SUBDIVISION REVIEW SHEET

<u>CASE NO.</u>: C8J-2019-0143.3A <u>P.C. DATE</u>: 2/28/2023

SUBDIVISION NAME: Howard Lane Phase 3

CITY OF AUSTIN – TRAVIS COUNTY – SINGLE SUBDIVISION OFFICE SUBDIVISION APPLICATION – MASTER COMMENT REPORT

SHEET 1 OF 5

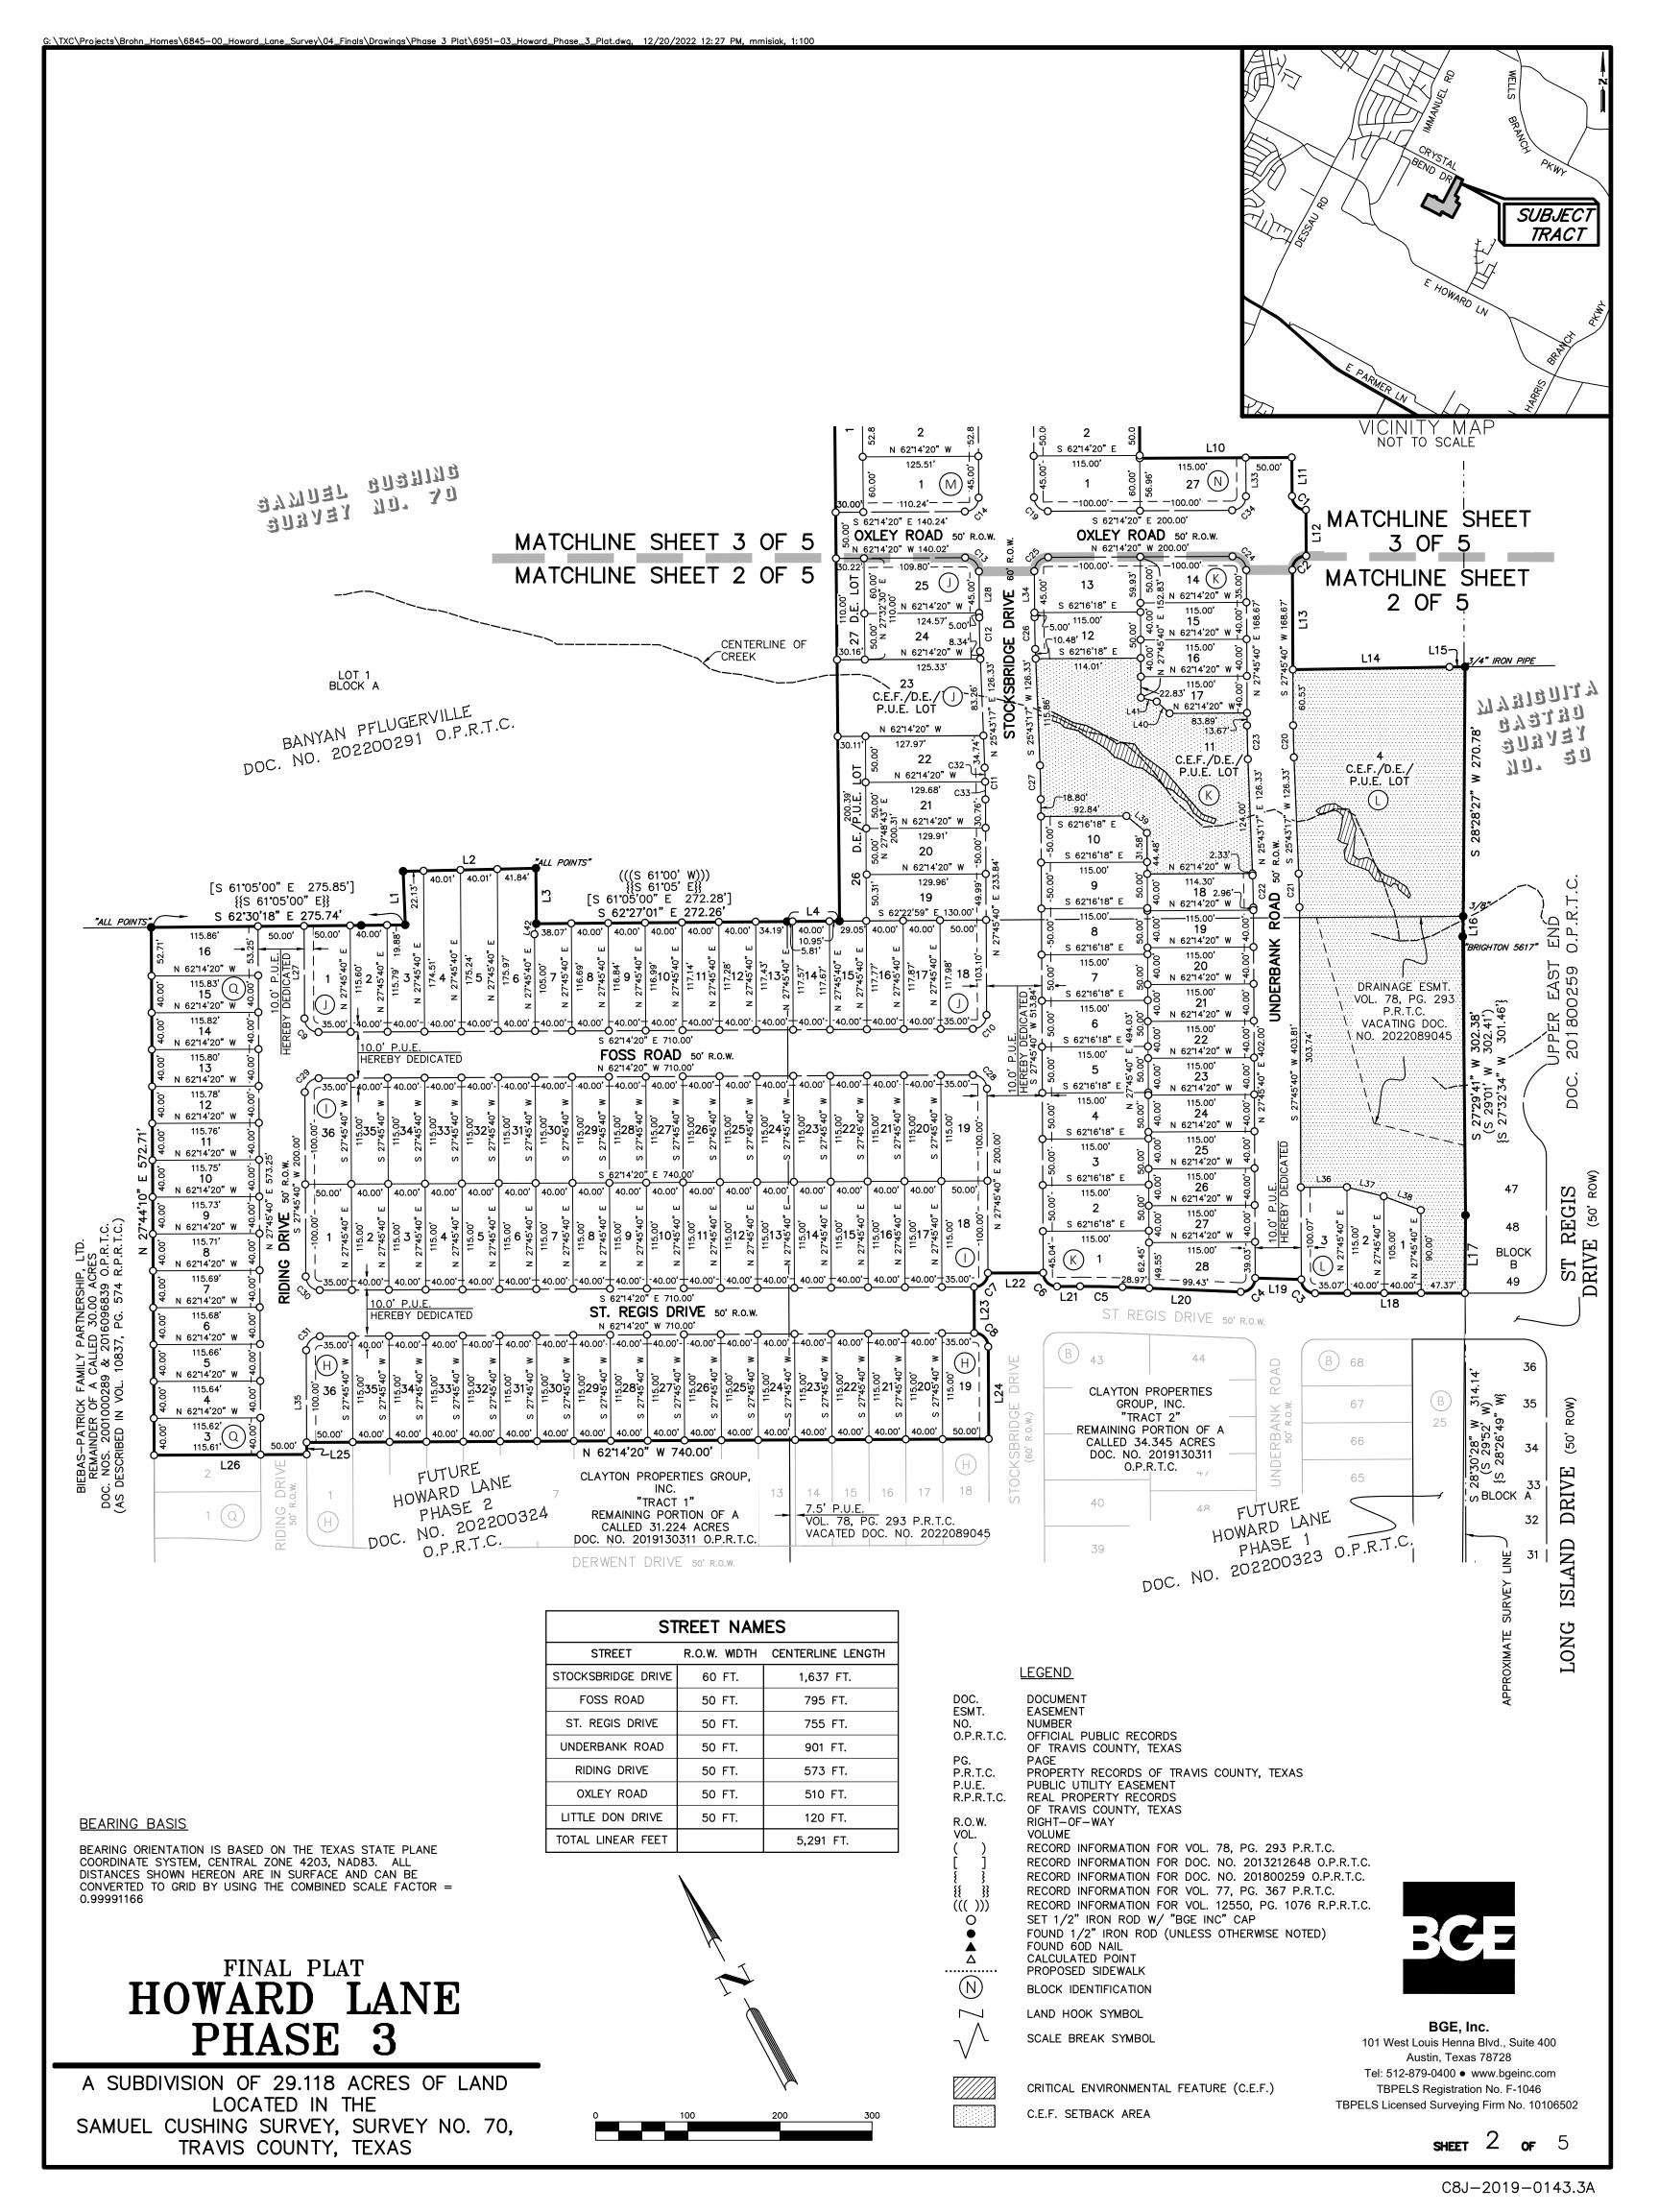
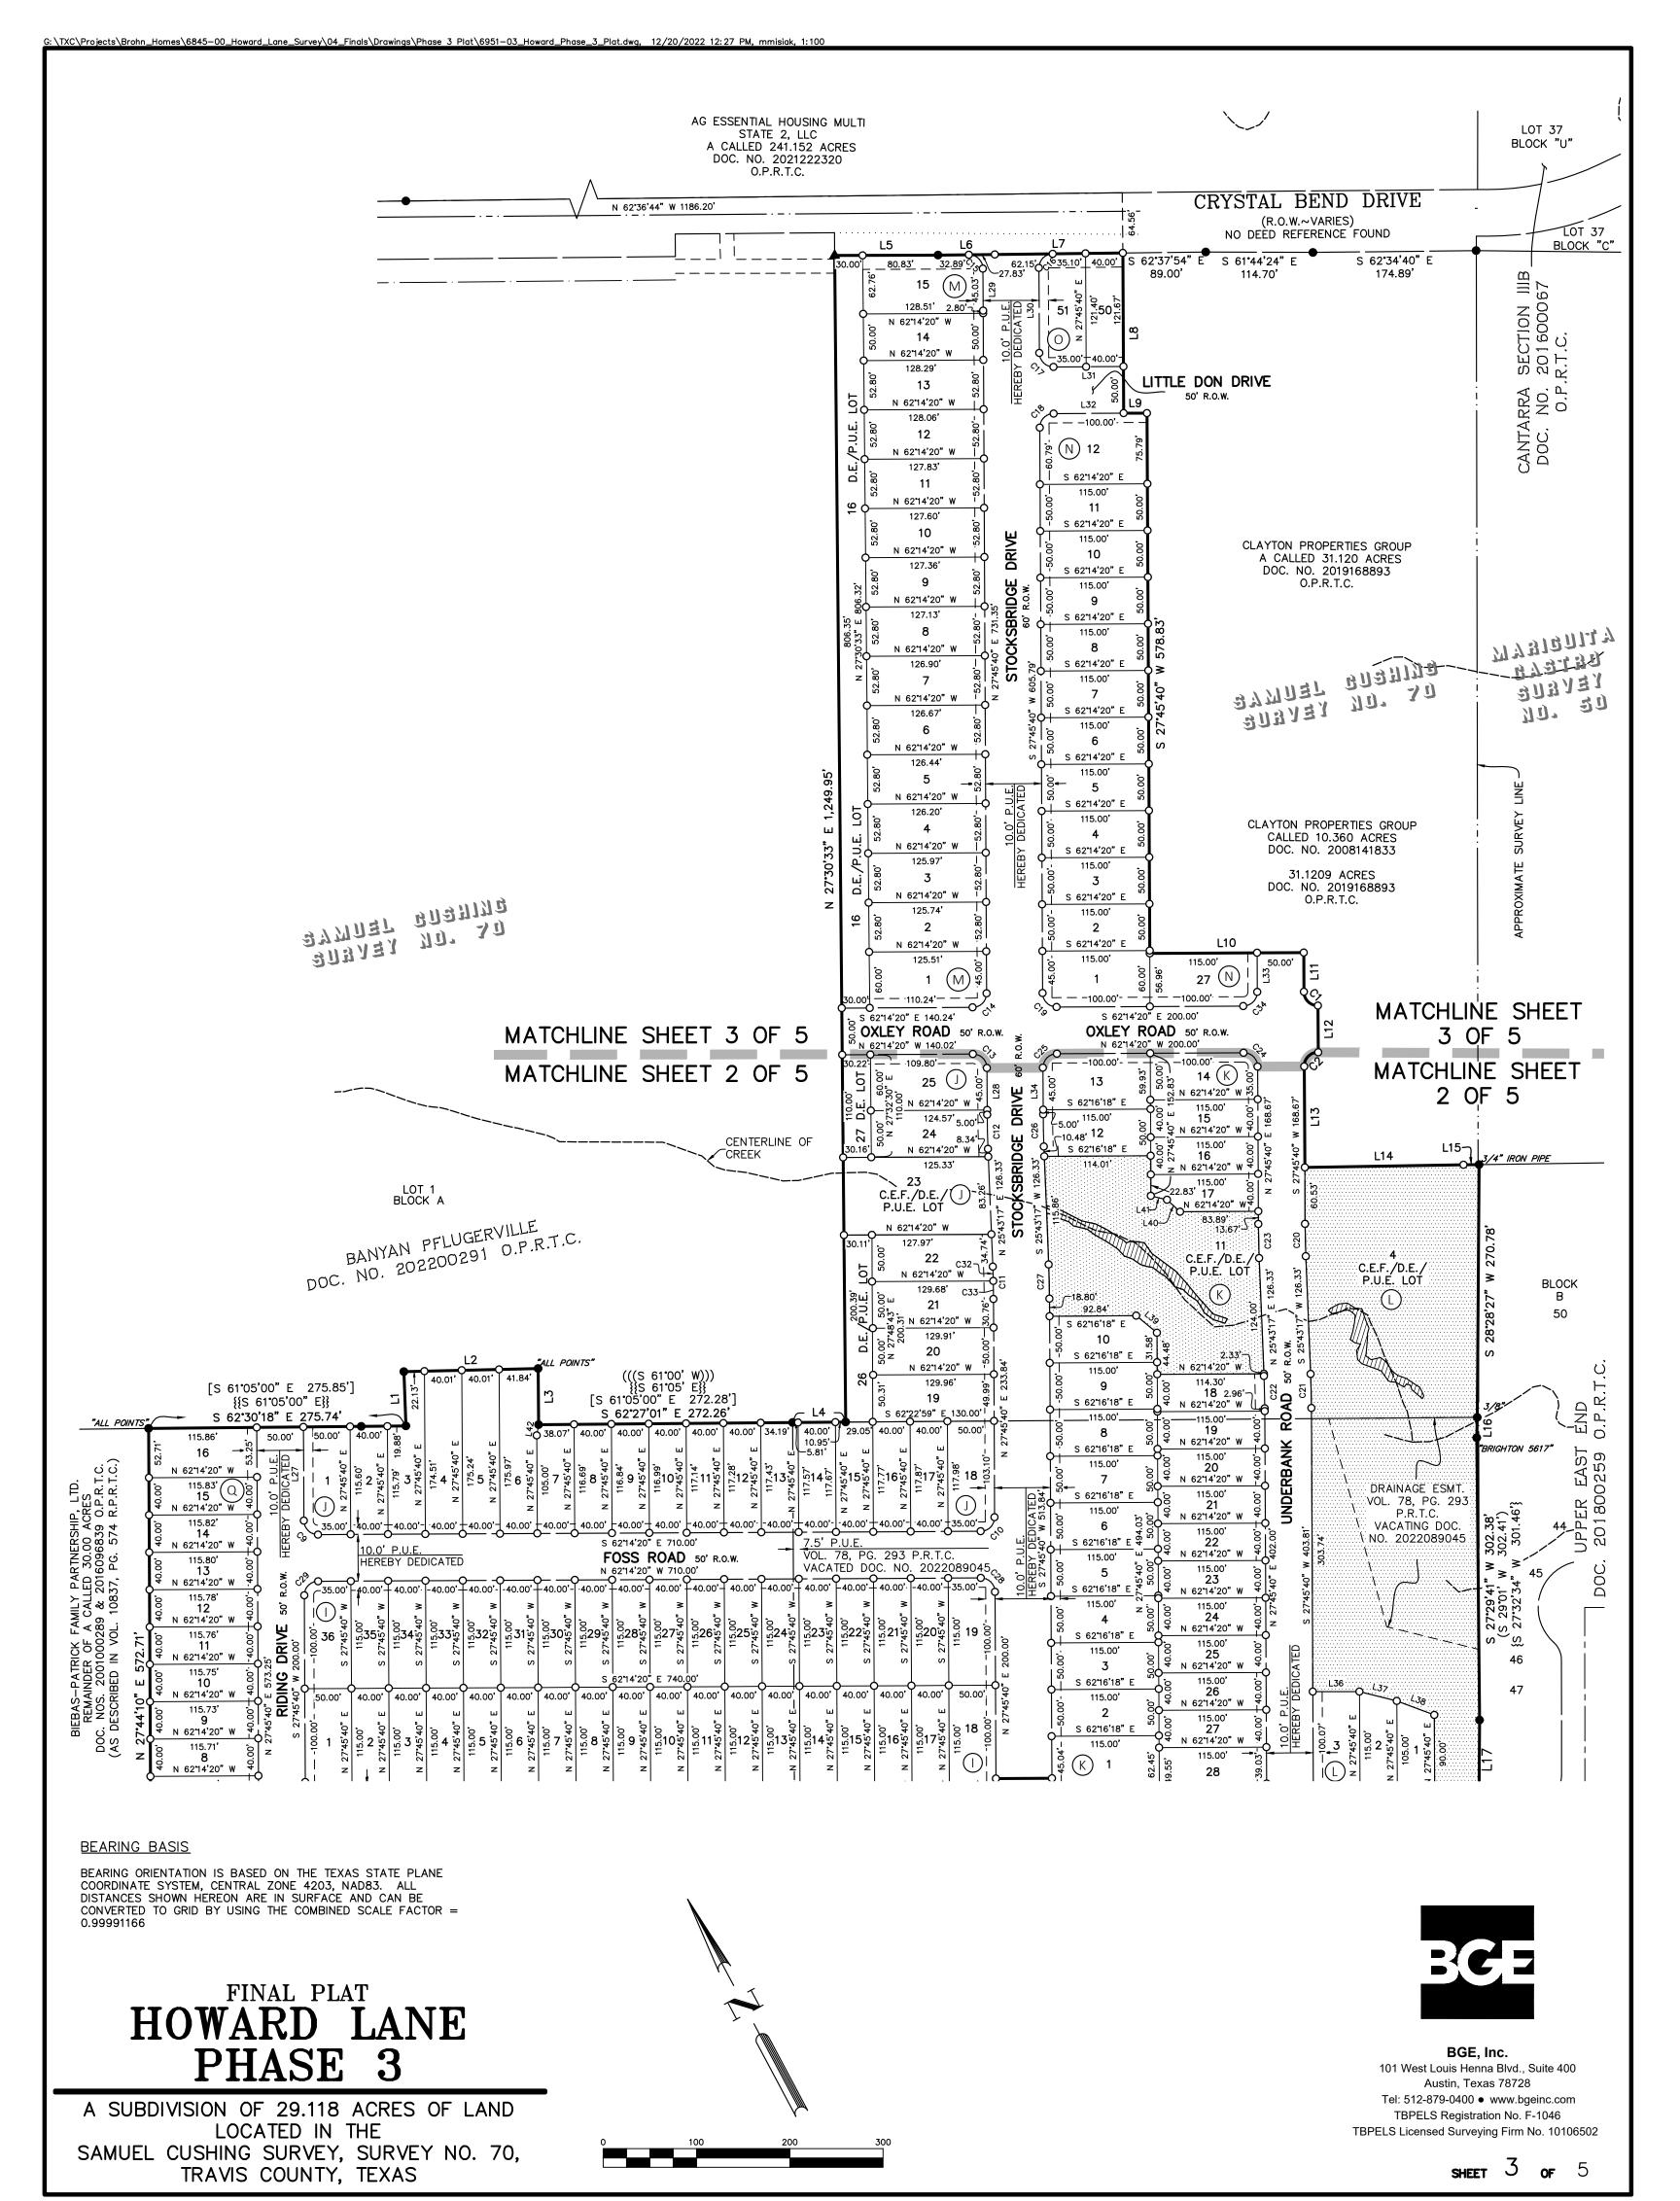
Fifteen (15) foot electric distribution, electric telecommunications, and electric fiber easement (ETE) is required adjacent to Crystal Bend Drive R.O.W. Show the easement on the face of the plat.

EL 2. Please modify note 11 on sheet 5 to include the 15' ETE as requested on EL 1. (e.g. 10' PUE & 15' ETE as shown are hereby dedicated).

Additional information: {This reviewer cannot establish wetland CEF protection provisions. e.g. Clearly show the boundary of the wetland CEFs and clearly label the features: "WETLAND CEF" on all plat sheets where they exist. FYI the wetland CEFs are shown but not labeled on Sheets 2 and 3 of the plat.}

- 1. Sheet 2 please remove Future from the adjacent recorded Howard Lane Phases 1 and 2.
- 2. Please add in the Vacation document number for the DW Patrick Addition in the owner's statement.
- 3. Denise Lucas has retired, please update the Development Services block with José G. Roig, Interim Director
- 4. Parkland fees and TIA mitigation fees are due.

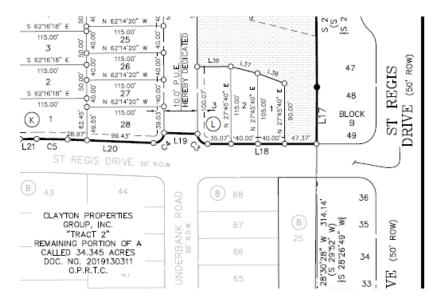
- AD1: This plat review is rejected for the following reasons:
- AD2: Please update label for **E WELLS BRANCH PKWY** the directional E must be included in the vicinity map
- AD3: Please remove all forms of punctuation after abbreviating street types or directionals on all pages including the street name table
- AD4: **DERWENT DR** is not reserved for Howard Lane Phase 2. Please remove
- AD5: STOCKSBRIDGE is reserved. Reservation is updated as STOCKSBRIDGE DR
- AD6: Please explain if **LITTLE DON DR** will continue to the east and connect with another street or end as a cul-da-sac
- AD7: Please remove ST REGIS DR the callout label shown on the following image

NOTE: Punctuation causes confusion for first responders

NOTE: Addressing recommends to please place labels directly on the ROW and not as a callout on a parcel

NOTE: Directionals (such as N, E, W or S) are required before a street name when a street crosses over designated zero range boundaries. Without the directional, duplicate addresses would occur. It is important to include the directional in the street name label.
